OUR REF: 213366-L001014

YOUR REF: MP 10_0136

**RE: MODIFICATION OF CONCEPT PLAN MP 10_0136 RIVERSIDE PROJECT
TEA GARDENS REQUEST FOR INFORMATION**

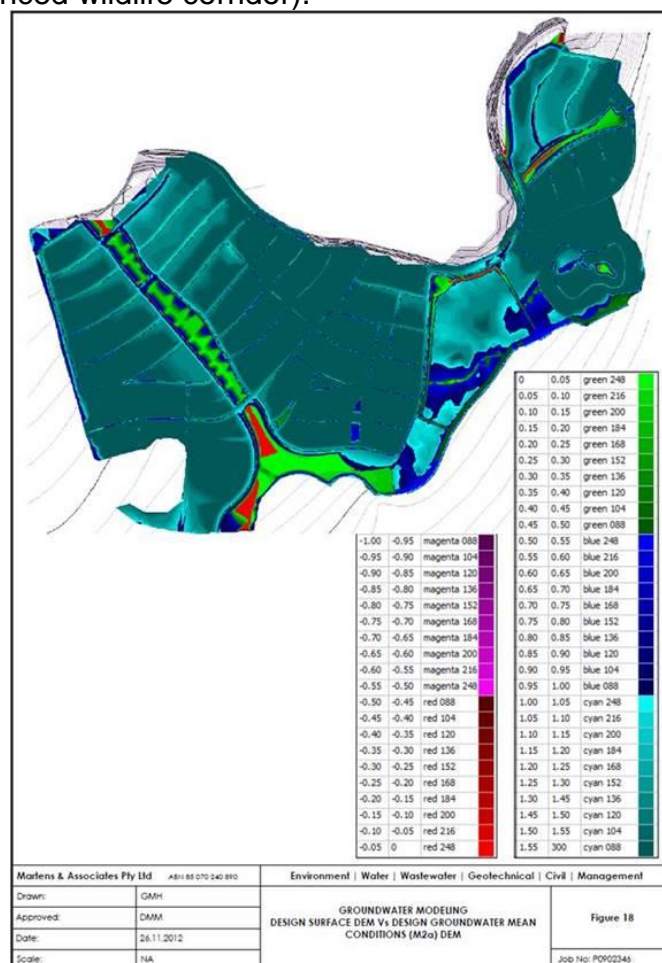
- Identify the proposed changes to the IWCMS and Flood Study, and justify why these changes are required (i.e. is it to comply with the conditions of approval or another reason).

Specifically, in relation to the Flood Study (Tattersall Lander) section of the report (Attachment 7), **Section 1.1 provides a summary of the proposed changes and the reasons why.** Further detail is provided below;

Mostly the modification entails a reduced overall footprint for ecological reasons, which had minimal impacts on the floodways. Design changes include;

- Monkey Jacket Branch - levels are exactly the same, although the horizontal geometry has changed to suit revised street pattern – the downstream outlet is in the same position, but the upstream end has been shifted approx. 80m north.

- South Branch – Levels and location remain unchanged, other than the removal of the existing basin at the bottom of this corridor – was included in the 2013 modelling as existing but was not part of the approval.

- West Branch – location unchanged, although upstream end truncated by 90m which had included excavation of the reserve between the development and Toonang Drive (to collect and direct discharge onto the site from Toonang Drive culverts). Invert levels unchanged at bottom of site, progressively deepened up to 250mm lower at top end of site to provide additional depth/capacity to receive flows from upstream culverts that were previously collected via the open excavations. I believe the only place any of these levels appear in the application documentation is where culvert invert levels are noted on the “Preliminary Drainage Design Details” plan as Attachment 1A to the Martens Concept IWCMS report but they were part of the DTM models used for the flood modelling and cut/fill plans. The lowering was done with the groundwater levels in mind, and only lowered so much as to not interfere with groundwater - This is illustrated in Figure 18 from the original IWCMP (reproduced below) as areas of greens i.e. there was still scope to lower without impacting groundwater.

- East-West Branch – no changes to levels, generally wider (as it corresponds to the enhanced wildlife corridor).

A plan of the intention is indicated below:-

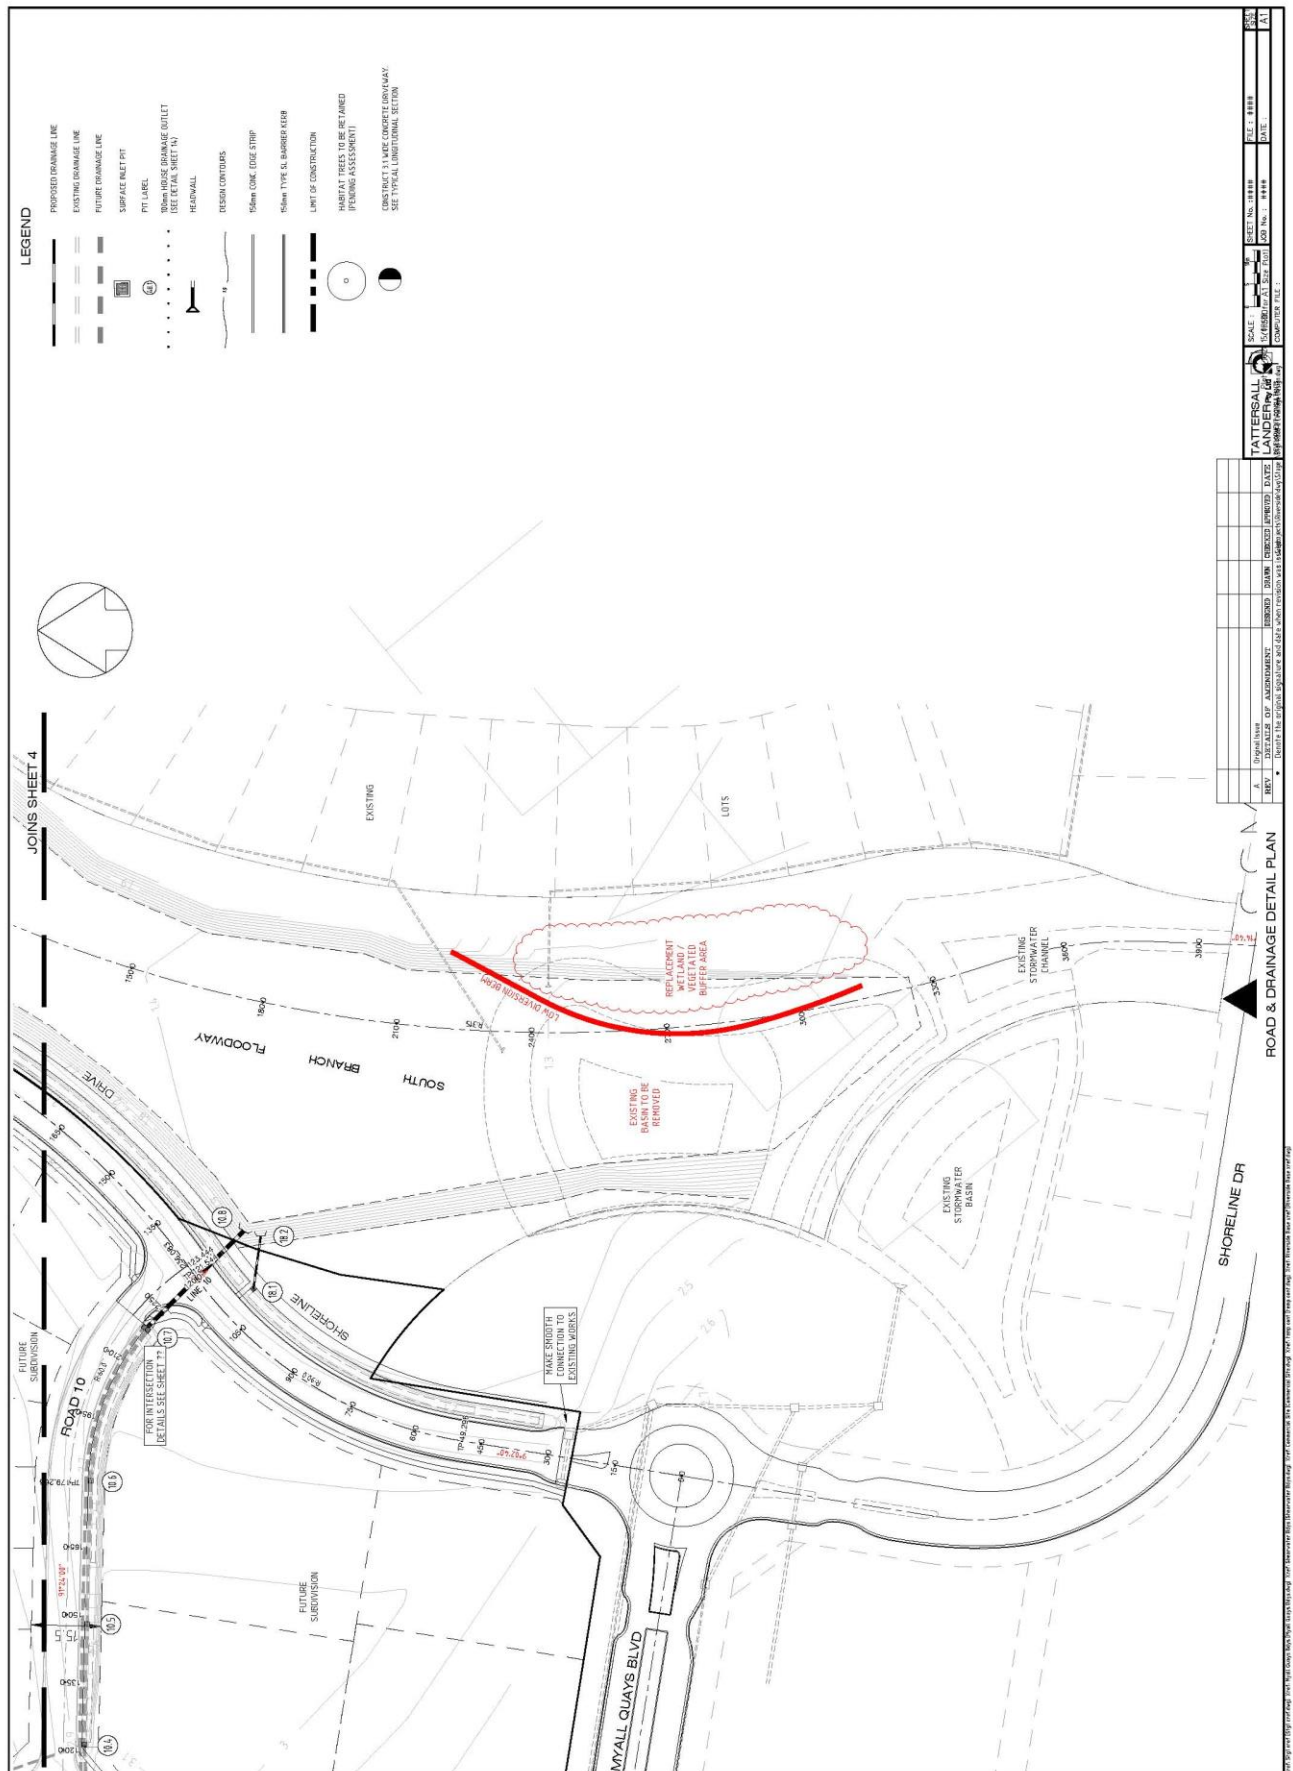
MidCoast Council (MCC) raised issues about the drainage channels, their depths and whether they were intersecting groundwater. The Applicant indicated that the most significant changes were in horizontal alignment and some minor deepening of the West Branch by 250mm, which has again been made without intercepting groundwater. The advice provided the following summary:-

The basin 8C approved in DA 433/2011 and DA 341/2003 (modified) on the South Branch, specifically noted on the Concept Approval as not being approved as part of the DPE process, is proposed to be removed and replaced by a constructed vegetated swale that would provide at least the equivalent water quality treatment.

It was offered that the changes to this basin would be undertaken in the Stage 1 Construction Certificate works of the project.

Thanks for the time today to discuss and resolve the outstanding issue associated with the existing Myall Quays water quality basin 8C and the southern floodway within the modified Riverside Concept layout. I commend you on the professional approach taken by providing analysis based on checking and running the flood models to determine velocities, water levels and storm events which would drive flows within the south branch floodway.

The evidence-based approach provides confidence to Council that the existing water quality treatment provided by basin 8C for several lots in Leeward Circuit can be suitably modified to ensure that there is no net change in treatment of the existing stormwater discharge as part of the final design of the south branch floodway. The commitment to undertake replacement action of the basin function within Stage 1 and the design work in the first overall DA for the development is satisfactory.

As such all remaining issues have been addressed and a suitable pathway for incorporation of an agreed design into future development applications and stages is provided. There are no further water management matters that need to be addressed in the modification.
